UNITED STATES PATENT AND TRADEMARK OFFICE

10/597,158

Office Action Summary	Application No. 10/597,158	Applicant(s) WAGENER ET AL.	
	Examiner JEFFREY ALLEN	Art Unit 3781

DETAILED ACTION

FIG. 2

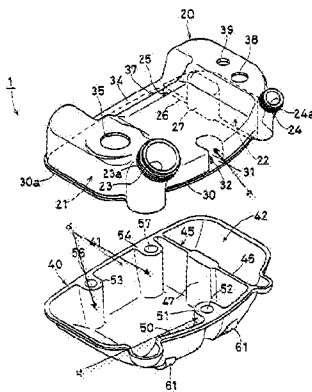
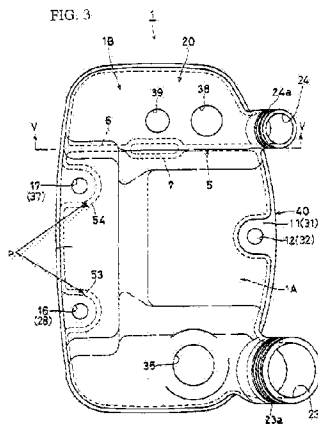
3. Regarding claims 1-6 and 8, Yokochi discloses a tank for oils or liquids comprising a tank part (1) having a tank volume, a fastening means (81) capable of fastening the tank to a surface of a motor vehicle made up of screw connections that pass through the tank volume in a leak proof manner with a portion of the screw connections are spaced from the tank part, ducts (d, Fig. 2 below labeled by examiner) formed by an inner surface integrally formed with the tank part (abstract) extending continuously within the tank part on an outer circumference of the tank part that screws extend through, a tank cover (col. 4, lines 16-18), a filler neck (23) and two connection pipes (73 and 76). The ducts have a dimension that is less than a dimension of the depth of the tank and recesses are provided on the circumference of the tank, this creating a space between the ducts and the tank cover (Fig. 4), the ducts further having one or more inner surfaces having a first length section and second length section,

wherein the first length section has a greater diameter than the second length section and a stepped portion connects the length sections with the screws being in contact with the stepped portion. The screws are premounted on the tank prior to use and an end of the each of the screws is spaced from the tank part walls and located outside the tank volume (Fig. 6) so that the tank can be mounted. The tank further providing positioning aides (p) located on an outer surface of the tank part in an area of first and second ducts.

4. Yokocho fails to teach wherein the fastening means and ducts are surrounded by the tank volume such that they are spaced from the wall, and wherein one end of the fastening means is surrounded by the tank volume.
